(NEW) Q+A QUESTIONS + ANSWERS – Questions submitted September 21-27, 2024

Q+A QUESTIONS + ANSWERS – Questions submitted through September 20, 2024

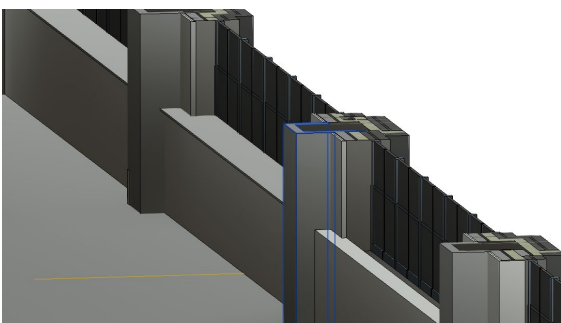
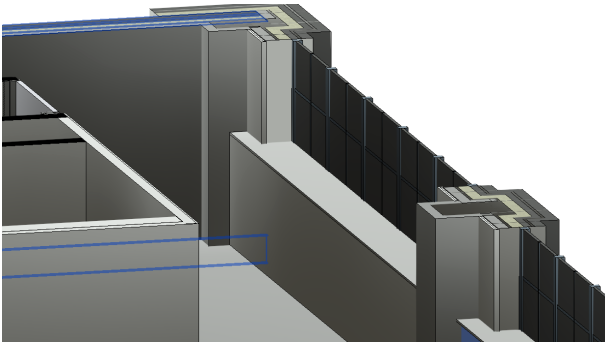
Q. If a student wants to open the 7th floor between columns, is there a beam connecting the columns?

A: There are no beams. The ceiling is a flat concrete surface. Please see this image below. This image was inadvertently left off of the Q+A document published this morning and I will be circulating it to everyone.

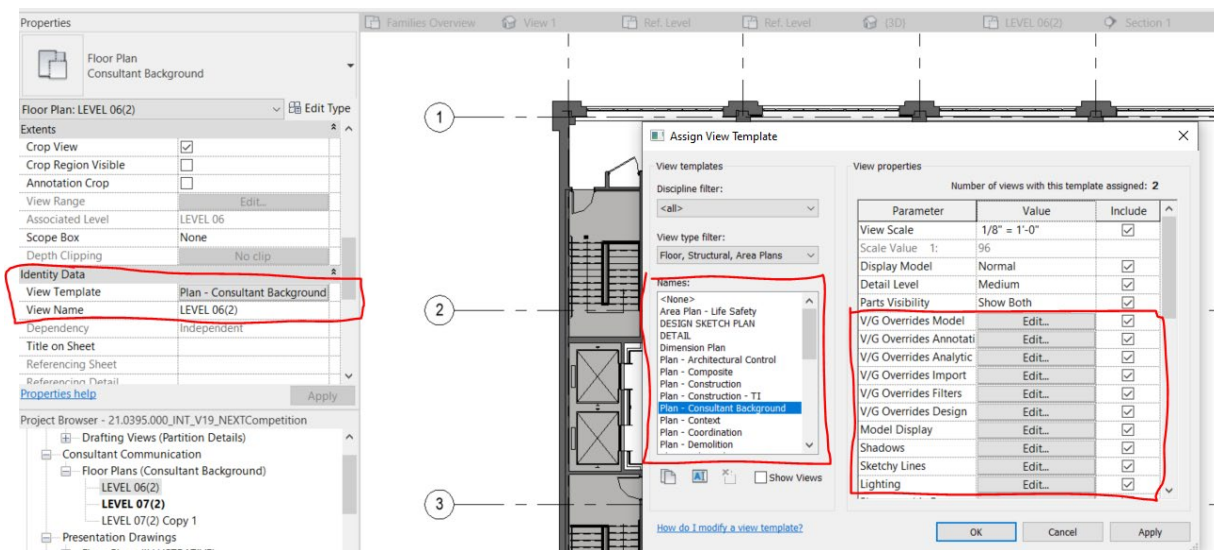
Q: I have a question in regard to working on the REVIT file. When I click on the Consultant Communication: Floor Plans (Consultant Background), no walls or furniture will appear when I place them. That being said, what plan/view/ layout is the best for us to design in or what settings should we modify?

A: I'd suggest checking the parameters of the wall to see if it has any base offsets or base constraints (that's for walls):

For furniture, I would suggest changing/editing/creating the/a View Template that suits your needs.

It can be changed on the Properties tab > Identity Data > View Template, you can edit the templates or create a new one there.

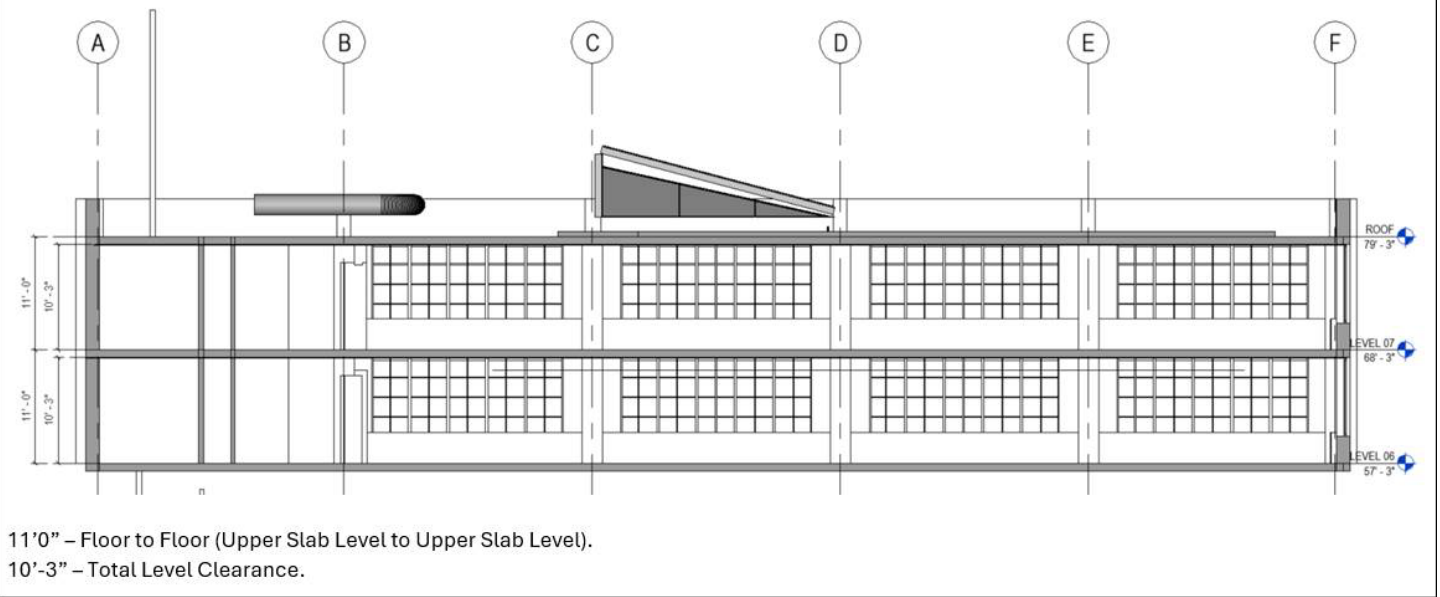
Q: Can you provide the slab to slab height/ceiling height in the project space? Is the ceiling totally flat or are there beams that need to be considered in planning the space?

A: Slab to slab (top to top) is 11’-0” with 10’-3” clearance and the ceiling is flat.

These are the dimensions:

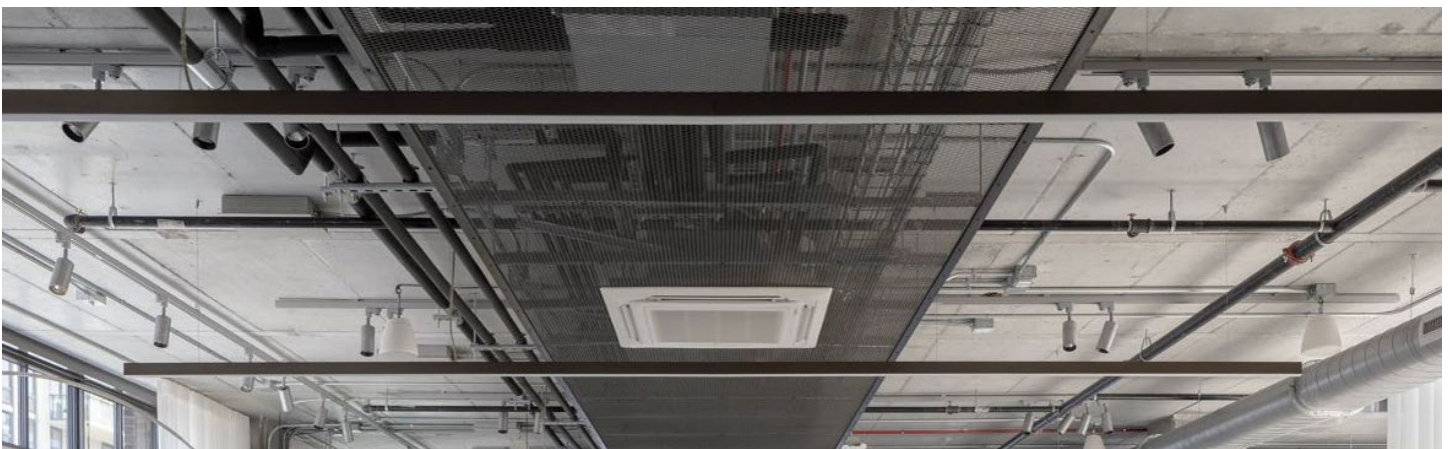
Q: Please provide specifics about the HVAC, such as is the duct work near the ceiling and/or along the exterior walls.

A: I have attached a few photos of the existing HVAC system as it is currently installed:

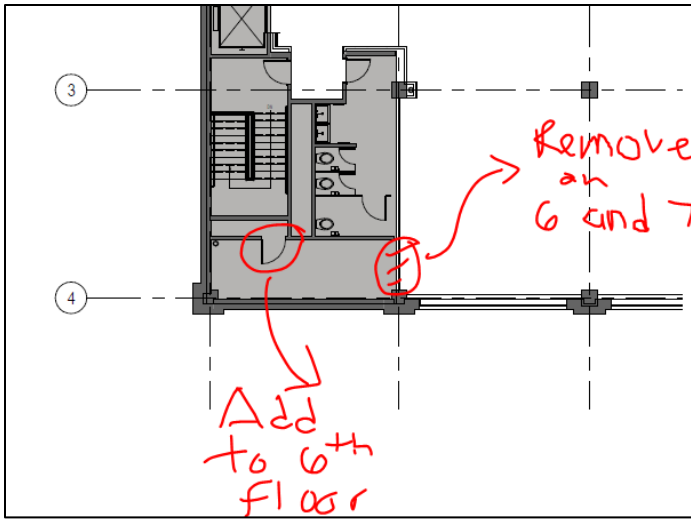
Q: Some of the existing walls do not go to the ceiling in Revit. Is this correct or should all existing walls go to the ceiling?

A: Assume all go to the ceiling.
